FINAL PLAT OF
"BLUESTEM ACRES SECOND ADDITION"
SEDGWICK COUNTY, KANSAS
IN THE SW 1/4 OF SECTION 9, T26S, R3W OF THE 6TH P.M.

RE: SUB 2001-47 -- Final Plat of Bluestem Acres Addition

STAFF REPORT

CASE NUMBER: SUB 2001-47 -- BLUESTEM ACRES SECOND ADDITION

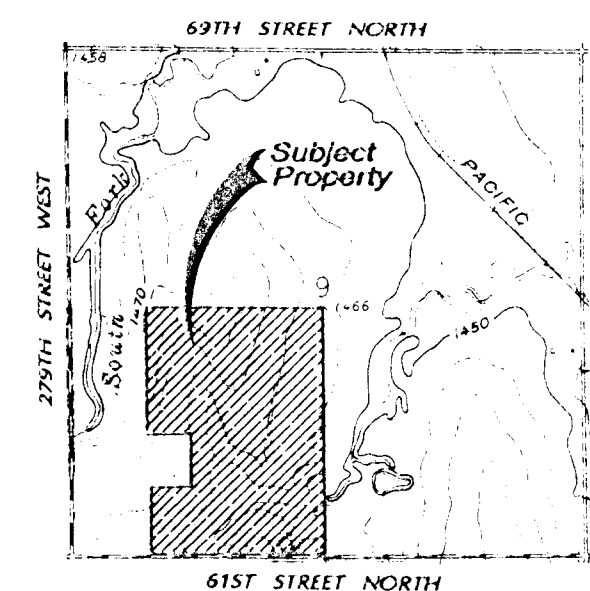
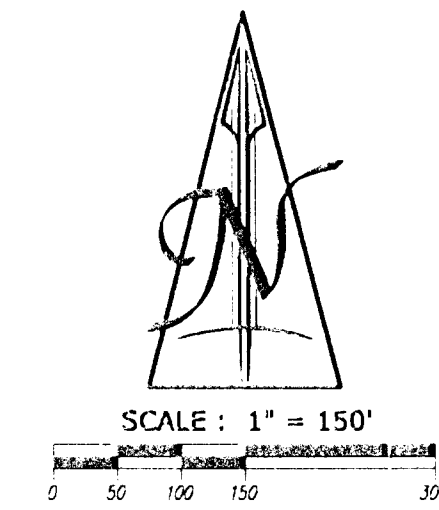
- A. Since neither municipal water nor sanitary sewer is available to serve this property, the applicant shall contact the Environmental Health Division of the **Health Department** to find out what tests may be necessary and what standards are to be met for approval of on-site sewerage facilities and water wells. A memorandum shall be obtained specifying approval. **A drainage plan is needed and additional floodway reserves denoted.**

- C. **County Engineering** needs to comment on the status of the applicant's drainage plan. A floodway reserve is needed in Lots 1 through 5, 13 and 14, Block 2, and in Lots 2, 3, and 4 of Block 1. **A lot grading plan is needed.**

- E. The Applicant proposes a 70-ft contingent dedication of street right-of-way extending to the east line of the plat in order to provide potential street connection to adjoining properties. On the final plat, the contingent dedication of right-of-way needs to be referenced in the plat's text as

becoming effective "upon the platting of any adjacent subdivision having a street connecting thereto". The dedication should be labeled as a "contingent street dedication".

- G. The County Fire Department/GIS needs to comment on recommendations for the plat's street names. *Busy Bee Court shall be labeled "Busy Bee Ct".*

- H. The pipeline easement agreements appear to indicate a 25-ft pipeline setback. This setback shall be indicated on the face of the plat and labeled as a Koch Pipeline Setback."

- J. The Subdivision regulations discourage the inclusion of pipeline easements within the perimeter of residential lots. *A restrictive covenant shall be submitted identifying the pipeline within the various lots.*

- L. The plat's text shall include language that a drainage plan has been developed for the plat and that all drainage easements, rights-of-way, or reserves shall remain at established grades or as modified with the approval of the applicable City or County Engineer, and unobstructed to allow for the conveyance of stormwater.

The 30-ft easements have been platted as requested.

- I. Lots 11, 14 and 15, Block 2 have been platted with increased setbacks in order to conform with the 200-ft lot width standard which is measured at the building setback line.
